AMENDMENTS TO THE DRAWINGS:

REMARKS

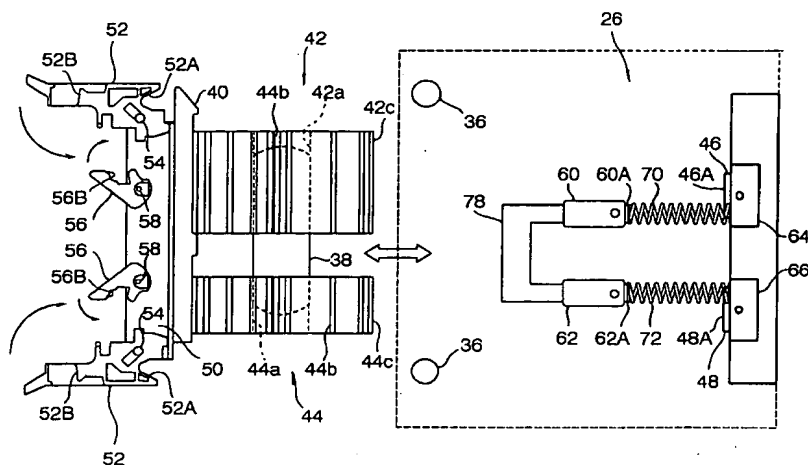
Figure 1 has been amended to revise reference character
"22" on the door to --24--.

Figure 1 has been amended to revise "22" on the door to --24--.

Fig. 5(A)

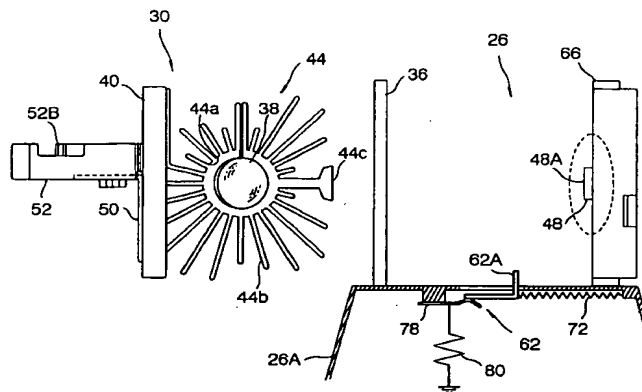
Figure 5A shows the light source unit removed and the sliding discharge electrodes in contact with the discharge

circuit terminal 78. Also see the discharge circuit terminal 78 connected to ground via 80.

Also illustrated is that the first power electrodes are spring biased in a direction of insertion and a direction of removal of the light source unit, the discharge circuit terminal connects to ground, and the light source unit comprising heat sink fins adapted as second power electrodes slidable into contact with contact surfaces of the first power electrodes.
